Access Compliance Report

Public Rights-of-Way

Intersection ID: 10024053	Main Street: CORONATION_BV	Cross Street: N/A	Location: NE
ADA ID: FE349C5CA5BC	Ramp Type: PerpDiag	Initial Pass/Fail: Fail	Overall Compliance: No
Codes/Mitigation Info/Possible Solution		Field Measurements/Component Compliance

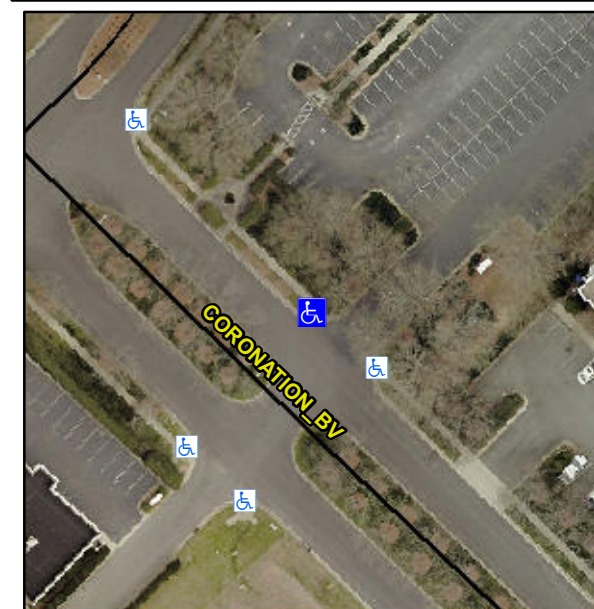
Not Found, R304.2.2, R304.5.3

Compliance	Description	Data	Compliance	Description	Data
N/A	Ramp Length (in)	78.0	No	Ramp Slope (%)	8.6
Yes	Ramp Width (in)	48.0	No	Ramp XSlope (%)	3.3
N/A	Flare Type LT	N/A	N/A	Flare Type RT	N/A
N/A	Flare Slope LT (%)	N/A	N/A	Flare Slope RT (%)	N/A
N/A	Flare Traversable LT?	N/A	N/A	Flare Traversable RT?	N/A
N/A	Landing Length (in)	N/A	N/A	DWS Provided?	N/A
N/A	Landing Width (in)	N/A	N/A	DWS Contrast?	N/A
N/A	Landing Slope (%)	N/A	N/A	DWS Length (in)	N/A
N/A	Landing X Slope (%)	N/A	N/A	DWS Full Width?	N/A
N/A	Landing Curb? (Y/N)	N/A	N/A	DWS Offset (in)	N/A
N/A	Shared Landing?	N/A			
N/A	Gutter Ponding?	N/A	N/A	Gutter Slope (%)	N/A
N/A	Gutter Lip Ht (in)	N/A	N/A	Gutter X Slope (%)	N/A
N/A	Painted X Walk1?	No	N/A	Painted X Walk2?	No
	X Walk 1 Direction	To SW		X Walk 2 Direction	To SE
N/A	X Walk 1 Width (in)	N/A	N/A	X Walk 2 Width (in)	N/A
	X Walk 1 Slope (%)	3.2		X Walk 2 Slope (%)	2.5
	X Walk 1 X Slope (%)	1.0		X Walk 2 X Slope (%)	6.5

Remove & Replace Curb Ramp With Two New Directional Ramps or Equivalent.
